ECE/TRANS/WP.29/GRSG/2010/8
22 February 2010

REGULATION No. 116
(Protection of motor vehicles against unauthorized use)

Revised proposal for draft amendments to Regulation No. 116

Submitted by the expert from Japan */

Paragraph 6.4.2.1.

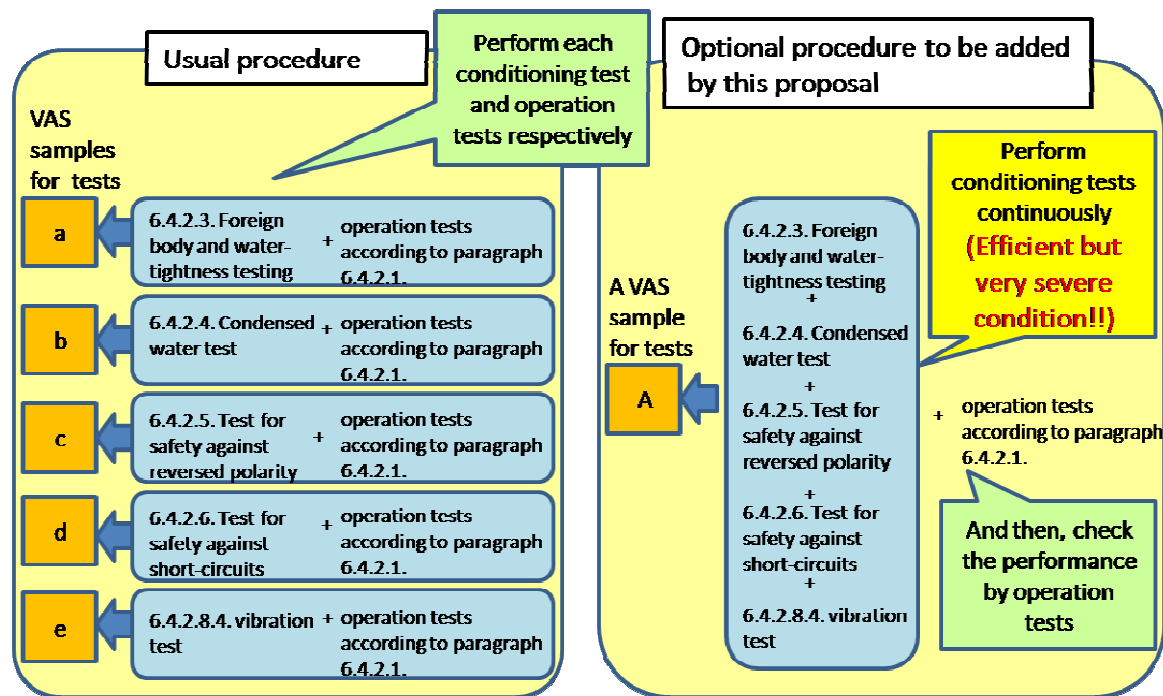
This proposal is to add an optional procedure to streamline the operation tests repeatedly required in paragraphs 6.4.2.3., 6.4.2.4., 6.4.2.5., 6.4.2.6. and 6.4.2.8.4. by adopting more rigorous conditions.

Performing some of the tests required in these paragraphs prior to the operation tests in series for a sample is more rigorous than performing one of these tests before performing the operation test with regard to test conditions.

This amendment enables exemption of the tests for a VAS approved as separate technical unit or an AS to be installed to the vehicle which is type approved. It is possible to apply vehicle type approval of the immobilizers and alarm systems without the type approval for components/separate technical unit, while some devices to prevent unauthorized use are not subject to such component type approval.

According to this amendment, manufacturers can choose this option to decrease their work for obtaining type approval, provided they have sufficient quality for a VAS to do so.
